Re: Crown-Indigenous Relations and Northern Affairs Canada's Response to Reply on the Review of the Licence Renewal Application for Hackett River Project, Type B Water Licence No. 2BE-HAK2126

Technical Review Memorandum

Subject: **Crown-Indigenous Relations and Northern Affairs Canada’s Response to Reply on the Review of the Licence Renewal Application for Hackett River Project, Type B Water Licence No. 2BE-HAK2126**

Figure 2: Site Layout, Hackett River Camp, 2015

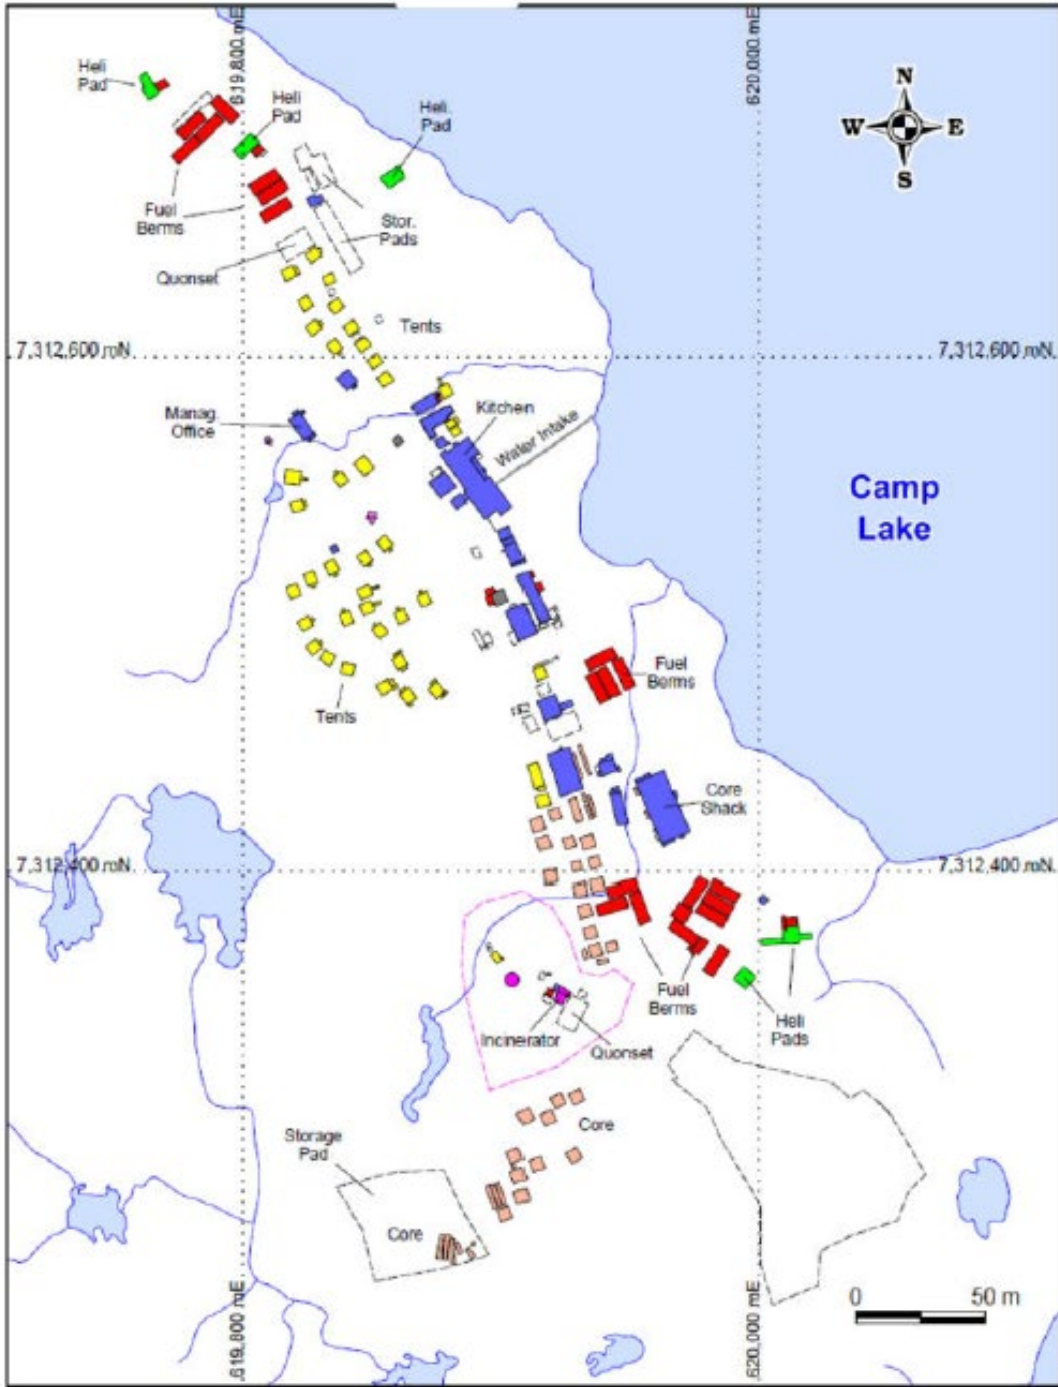
In the Spill Contingency plan section 5 Figure 2 as seen below show potentially up to 5 helicopter pads. Given that the image is from 2015 it is highly likely that the site has changed and potentially consolidated areas. All written mentions of the helicopter pads say that there are three.

(R-05) CIRNAC recommends that the plans be updated to correct for these discrepancies and submitted within 90 days for review. Note that submission of new plans with the annual report is not supported. New plans and updates should be submitted as stand alone documents for review.
